NHTSA SAFETY RECALL NUMBER 24V-505

IMPORTANT
	SAFETY
	RECALL
INTERIM Notice	
Brush Chipper Axle Mounting Hardware Replacement Kit (SVC2024-072)

Model:	BC1200XL
This notice applies to your vehicle,	
Serial No:

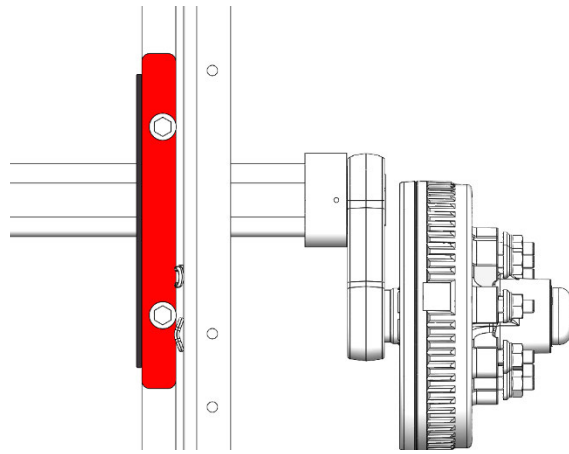
3. Inspect that block "C" (shown in red) is on top of main frame and thicker side is to the inside of the machine, block "A" (shown in blue) is on the bottom side of the axle hanger bracket, and block "B" (shown in black, for reference only), is between the chipper frame and the axle hanger bracket.
 - a. If blocks are **not** in the correct position:
 - i. Place suitable supporting device under one side of the frame.
 - ii. With opposite-side hardware still fastened, remove two bolts from raised side of machine.
 - iii. Place block "C" (shown in red) on top of axle frame, with thicker side to the inside of the machine.

- iv. Place spacer "A" (shown in blue) under axle hanger bracket.
 - v. Install bolts, washers, and nuts.
 - vi. Torque to 196 ft-lb/266 Nm.
 - vii. Remove support and lifting device.
 - viii. Inspect opposite side and repeat steps i-vii, if needed.
- b. If blocks **are** in the correct positions, torque all four bolts to 196 ft-lb/266 Nm.
- c. Re-torque axle mounting hardware to 196 ft-lb/266 Nm every 50 miles until no rotation is required to achieve specified torque.
